From: Lein, Jerry R.
Sent: Thursday, August 14, 2008 10:44 AM
To: TLangston@otpco.com; akoeckeritz@otpco.com; Jerome C. Kettleson
Cc: -Grp-PSC Commissioners; -Grp-PSC Public Utilities; -Grp-PSC Legal
Subject: FW: Pillsbury - Fargo Generation Outlet - PU 08 - 48 Additional Pole Moves
Attachments: 20080808102332744.pdf

103 PU-08-48 Filed: 8/14/2008 Pages: 7
Structure Location Changes and Commission Approval of Structure Location Changes

PROJECT: PILLSBURY-FARGO GENERATION OUTLET

DESCRIPTION _____ SEC. 25 TWP. 141N R. 51W
 COUNTY CASS STATE NORTH DAKOTA
 OWNER ROBERT KUKLOK ETUX ADDRESS 2814 162ND AVE SE ARGUSVILLE, ND
 TRANSMISSION FACILITY: PILLSBURY-FARGO 230 KV GENERATION OUTLET
 W. O. NO. _____ DATE _____ SIGNED _____

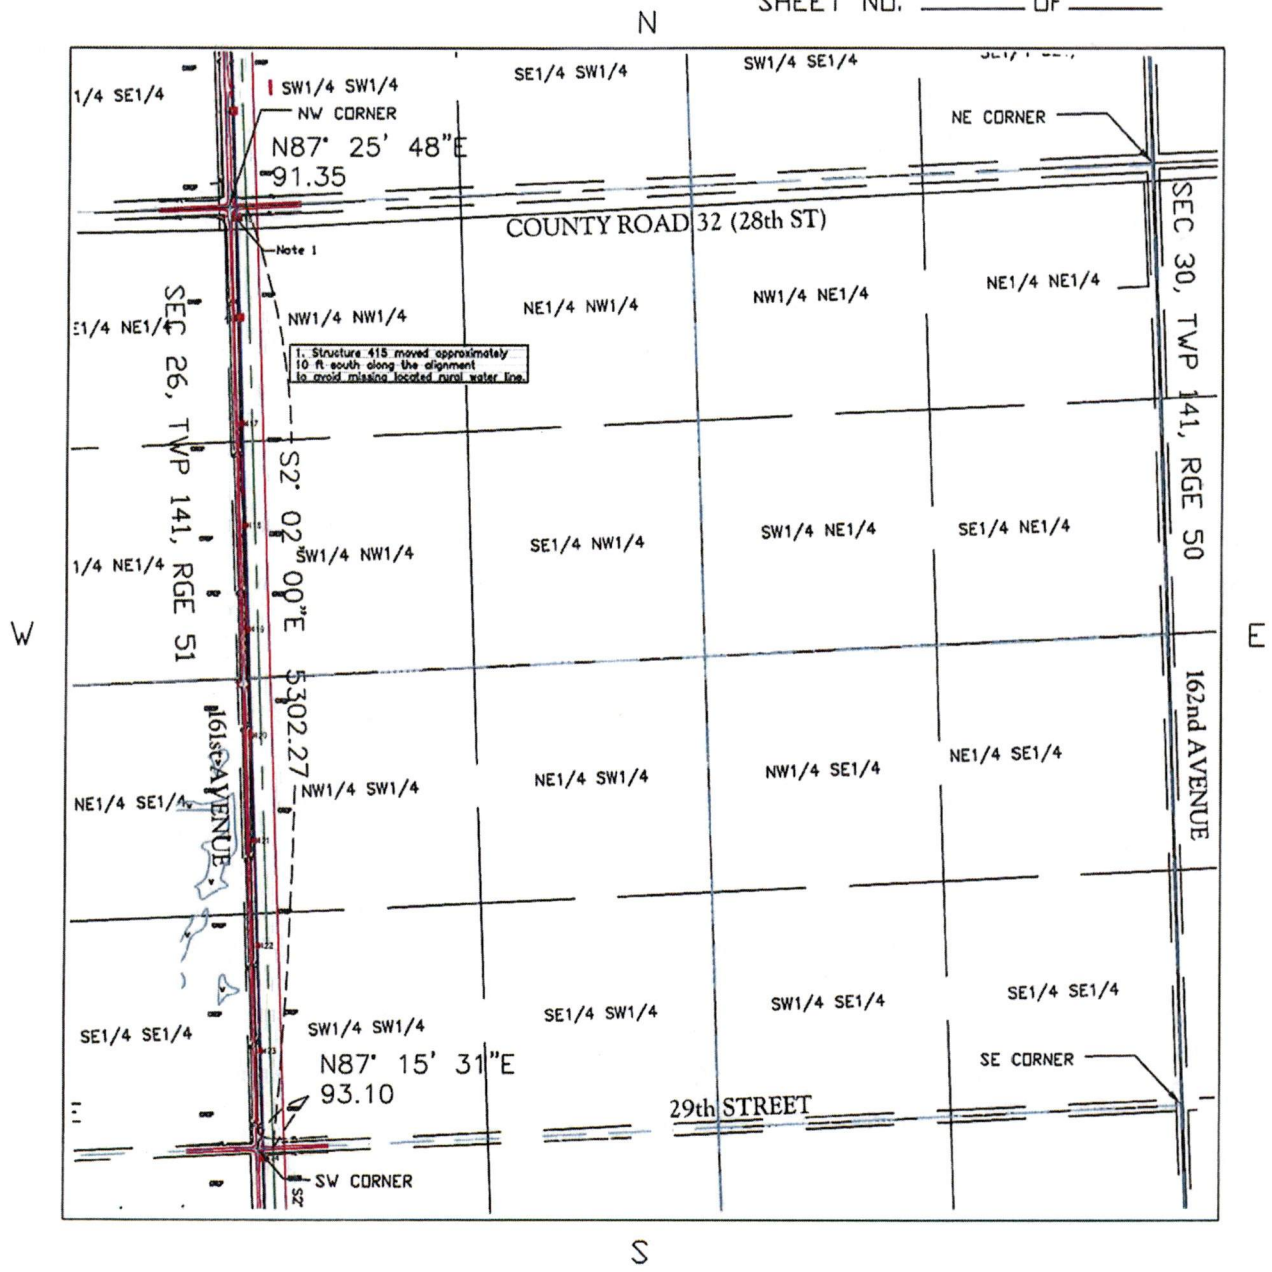
Structure 415 in Section 25 of Rush River Township would be moved approximately 10 feet south along the existing alignment to avoid a rural water line.

We hereby give approval, as owners, to relocate Poles No. 415 located in Section 25, Rush River Township, Cass County from the original route that was submitted.

In follow-up to discussions with the Commission during its administrative meeting yesterday, and pursuant to ordering paragraph #18 of the Commission's June 6, 2008 Findings of Fact, Conclusions of Law and Order in Case No. PU-08-48, please consider this to be Commission staff approval of the transmission line structure location changes described below and in the attached drawings. Thanks.

DESCRIPTION NE 1/4 SEC. 14 TWP. 141N R. 51W
 COUNTY CASS STATE NORTH DAKOTA
 OWNER FRANK J KASOWSKI SR ADDRESS PO BOX 370 CASSELTON
 TRANSMISSION FACILITY: PILLSBURY-FARGO 230 KV GENERATION OUTLET
 W. O. NO. _____ DATE _____ SIGNED _____

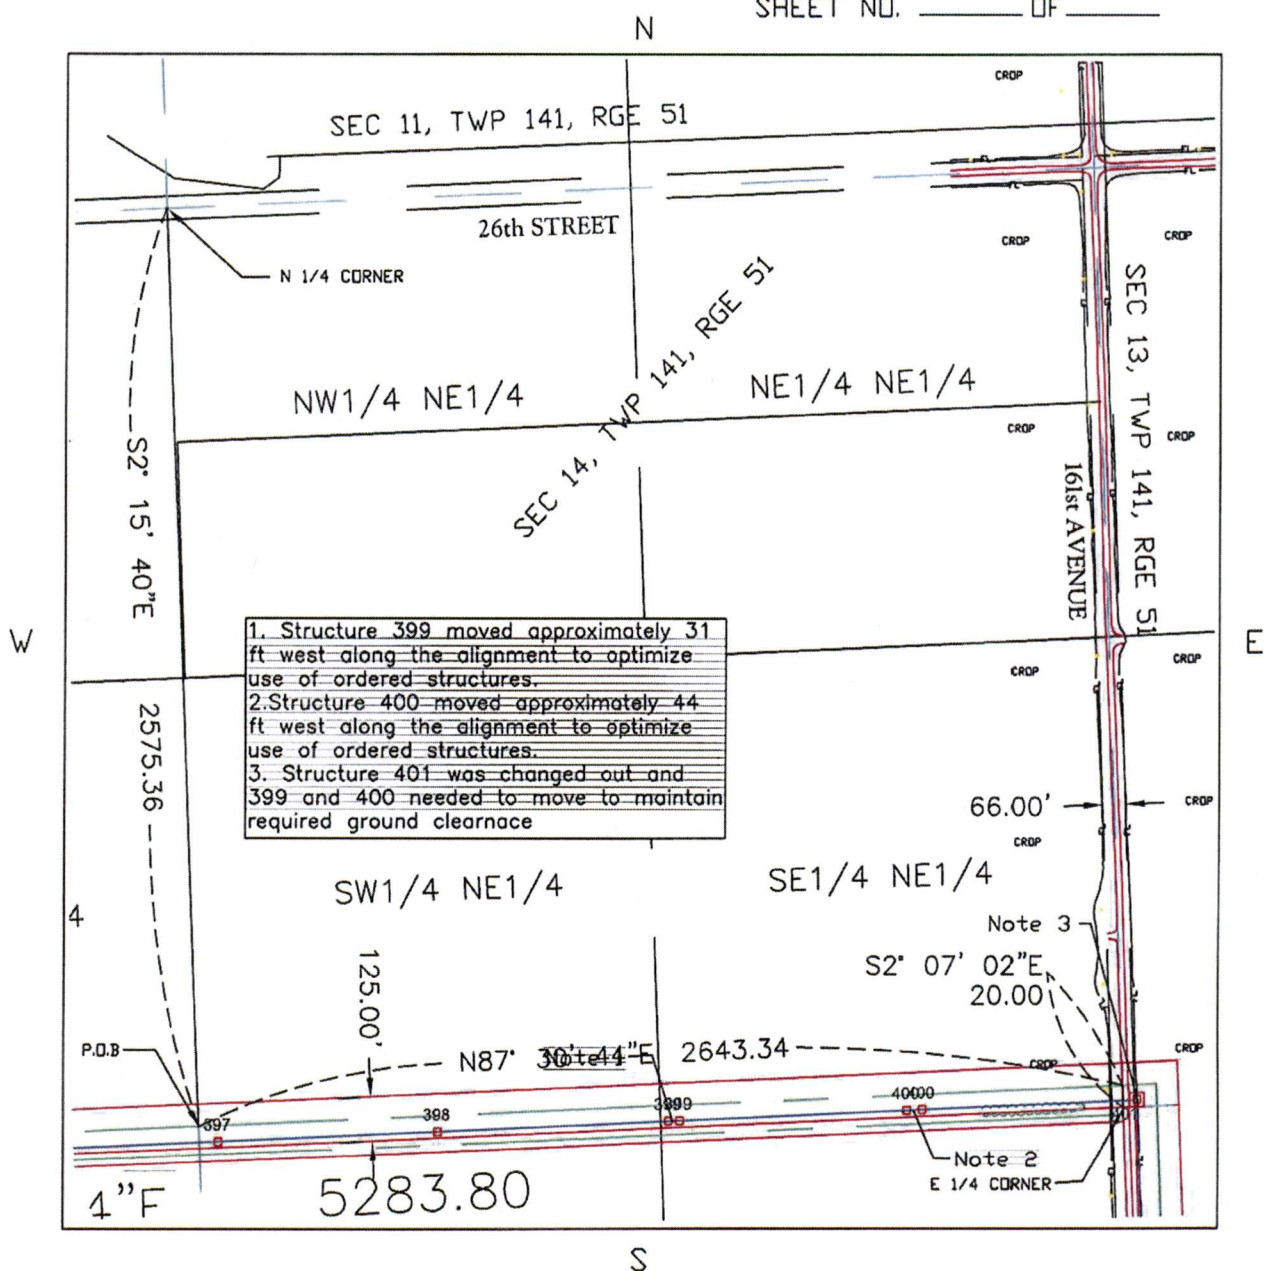
Structures 399 & 400 in Section 14 of Rush River Township would be moved 31 feet and 44 feet west along the existing alignment to maintain ground clearance after changing to a shorter structure for dead-end structure 401.

We hereby give approval, as owners, to relocate Poles No. 400-401 located in Section 14, Rush River Township, Cass County from the original route that was submitted.

DESCRIPTION GOVERNMENT LOT 1 SEC. 4 TWP. 141N R. 51W

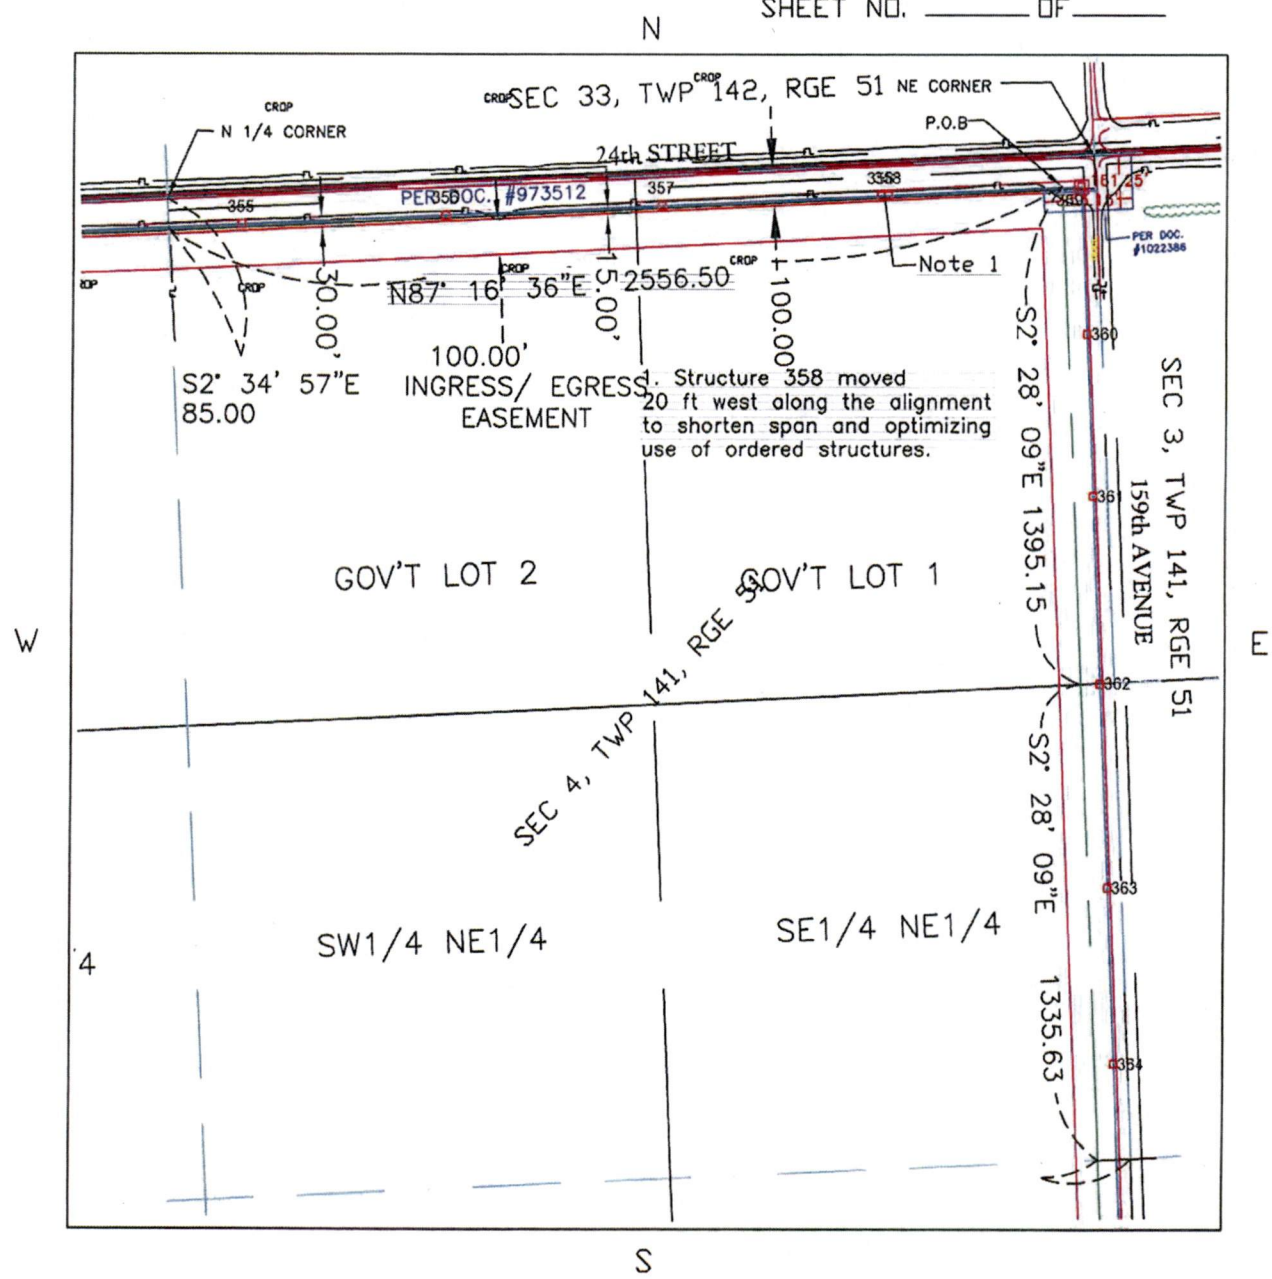
Structure 358 in Section 4 of Rush River Township would be moved 20 feet west along the existing alignment to shorten the span length and make optimal use of ordered structures.

I hereby give approval, as owner, to relocate Poles No. 358 located in Section 4, Rush River Township, Cass County from the original route that was submitted.
